Audubon Arkansas Comments

on Entergy's 2012 IRP

Prepared by
Paul Chernick

September 26, 2012

Figure 1: Entergy and Henry Hub Natural Gas Forecasts and Futures

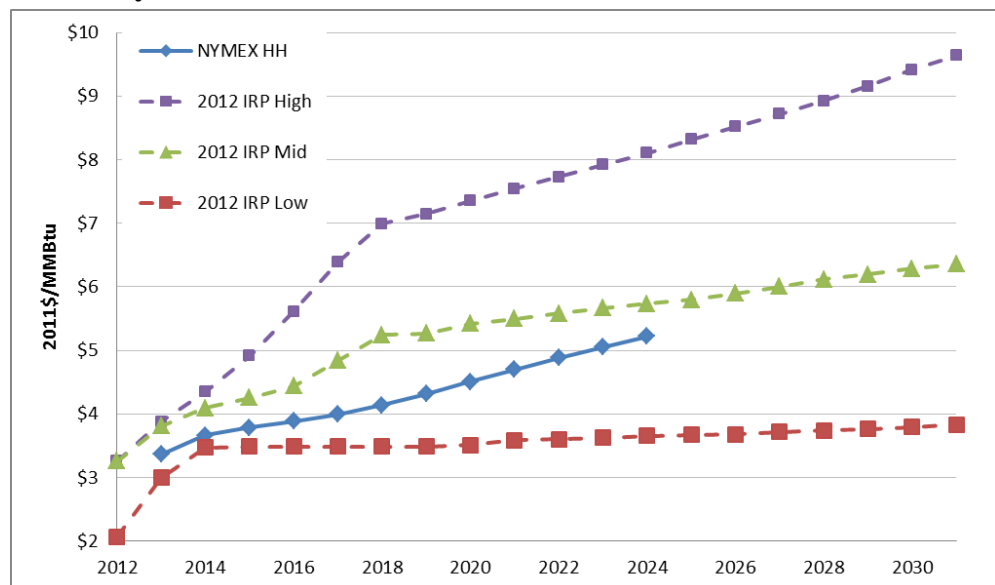
Natural-gas prices affect many important resource decisions, including whether to refurbish Entergy Arkansas's existing gas steam units and whether to spend hundreds of millions of dollars to keep the White Bluff and Independence coal plants in operation. The mid-range Henry Hub gas prices used in Entergy's IRP are considerably higher than current futures prices; see Figure 1.¹ Through 2019, the futures prices are closer to Entergy's low prices than its mid-range prices.

Both the NYMEX market participants and Entergy's forecasting staff attempt to capture much the same set of considerations (resource potential, changing technology, environmental regulations, demand from consumers, power generation, and exports). However, it is important to recall that the NYMEX prices are real prices, produced by the combined projections of a large number of partici-

The futures market is particularly valuable for updating price forecasts in periods of rapid change in underlying factors. Futures for the out years (2015 and beyond) fell steadily from early 2011 through April 2012, and have traded in a narrow range since. The Entergy forecast may have been developed prior to April 2012, in which case the Entergy forecasters would not have all the information available to the market.

Figure 2: Natural Gas Forecasts, Docket 09-024-U and Today

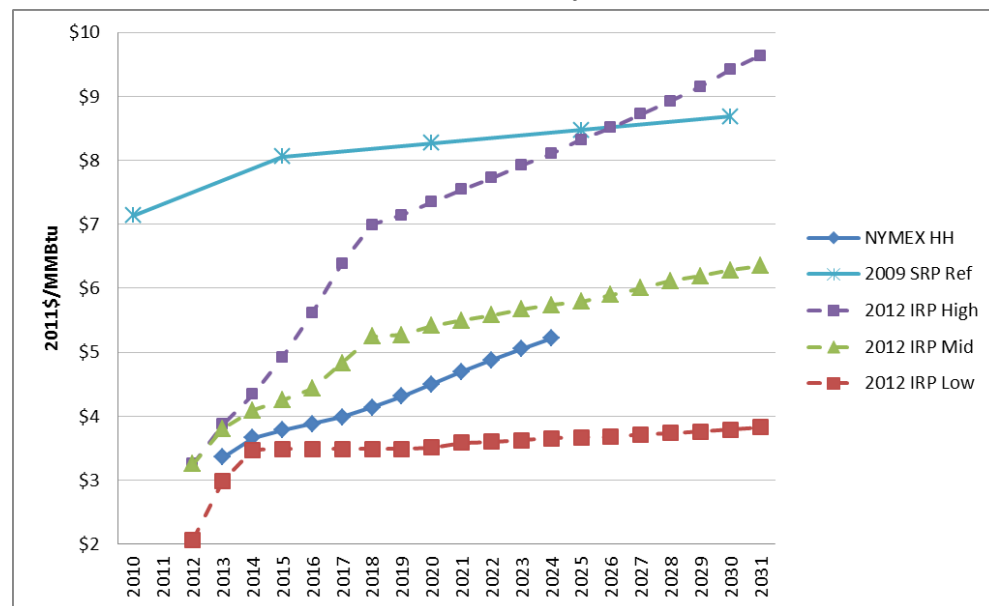
In terms of natural-gas prices, Entergy's analysis in Docket No. 09-024-U used price forecasts contemporaneous with Entergy's 2009 System Resource Plan. Figure 2 compares the reference gas prices from the 2009 SRP to the gas prices that Entergy (2012a, 10) projected in the 2012 IRP presentation. The 2009 reference-price forecast was greater than the current high forecast through 2025

and was more than \$2.50/MMBtu greater than the current mid-range gas forecast through the forecast period.

Revising the 2009 gas prices to current expectations would almost certainly eliminate any economic benefit from continued operation of the coal plants, even with optimistic assumptions about required environmental retrofits.
